CITY PLANNING COMMISSION

B. Special Permit for a 12,280 square foot Community Center, 5,500 square foot office and a parking lot for an expansion of the Salvation Army facilities on 2.0± acres in the Multiple Family Residential (R-2B) and General Commercial (C-2) zones.

PROPOSAL: The applicant is requesting the necessary entitlements to expand the Salvation Army facilities with a Community Center, office and parking.

APPLC. NO. P90-030 **MEETING DATE** March 8, 1990 **ITEM NO.** 12

EXHIBIT A
SITE PLAN

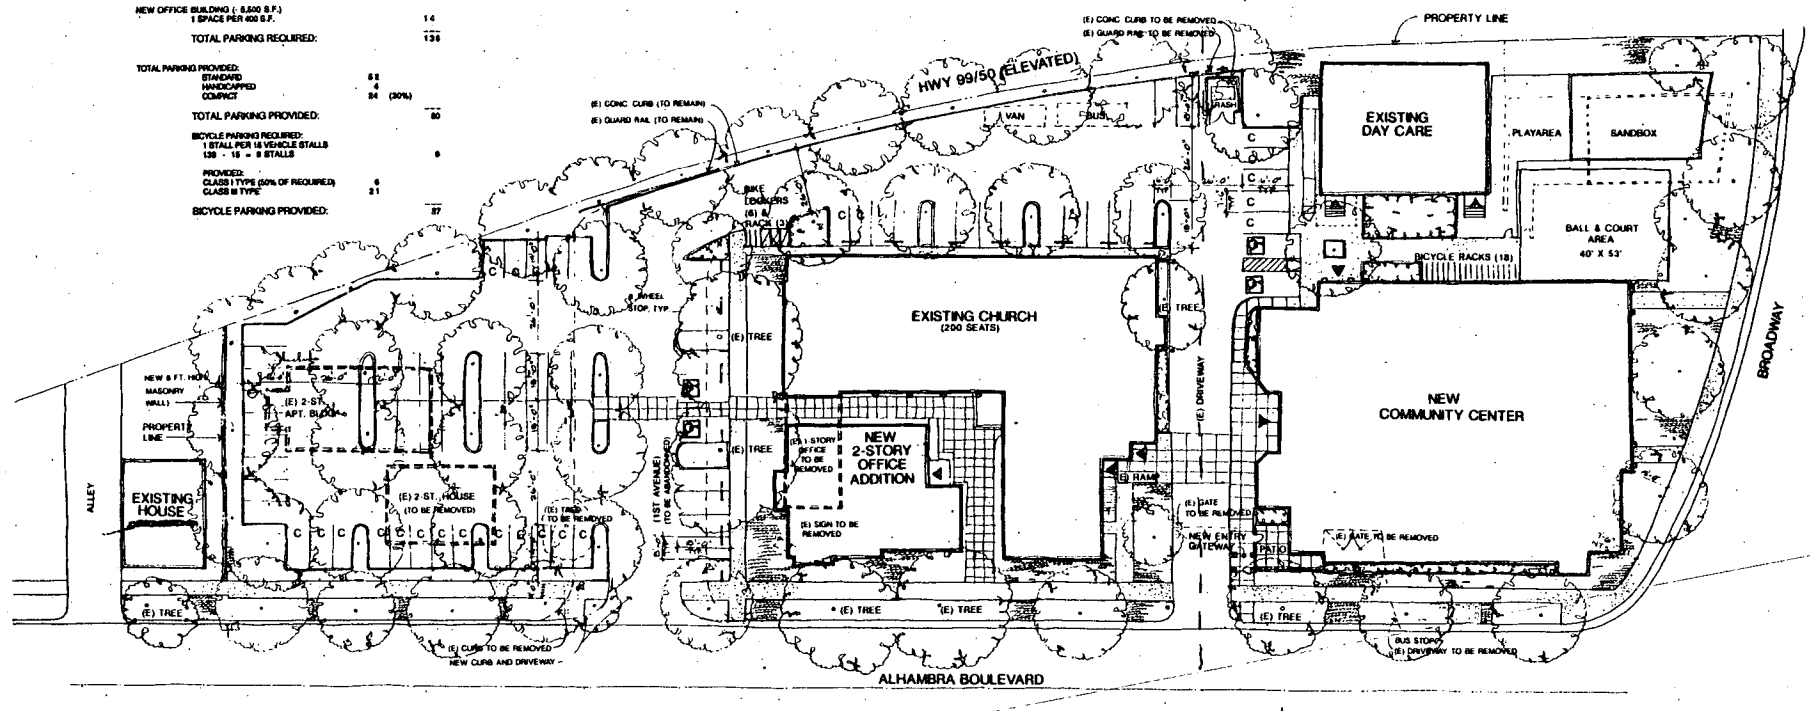
The two residential structures to be removed are proposed to be replaced with parking for the facility. The abandoned 1st Avenue also contains parking and a driveway. This parking area is adjacent to an existing house to the south located in the R-2B zone. The applicant has indicated on the site plan the required six foot high masonry wall along this property line in order to protect the residence from the parking area.

The site plan indicates 78 spaces provided on site. The applicant is requesting a variance to waive the remainder of the required parking. The applicant anticipates the majority of the uses will be the youth and elderly who are unable to drive. In light of this, the applicant has provided 3 times the number of bicycle parking facilities required. Shower and locker facilities will be provided for use by the gymnasium users as well as employees who may bike or jog to work. There are also bus stops on Alhambra Boulevard and Broadway which can transport people to and from the facility. Two bus and van parking spaces have also been provided. The applicant indicates the different facilities will be used at different times of the day. The church and Community Center will be used primarily on the weekends. The office and day care center will be used primarily during the week from 8 a.m. to 5 p.m. Staff finds that the parking proposed for the various uses on the site should be adequate and has no objection to the variance request.

4. A 6 foot high masonry wall is required on the southern property line as indicated on the site plan. The design and materials of the wall shall be subject to Planning Director review and approval prior to issuance of building permit.

9. The applicant shall provide the 27 bicycle parking facilities as indicated on the site plan.
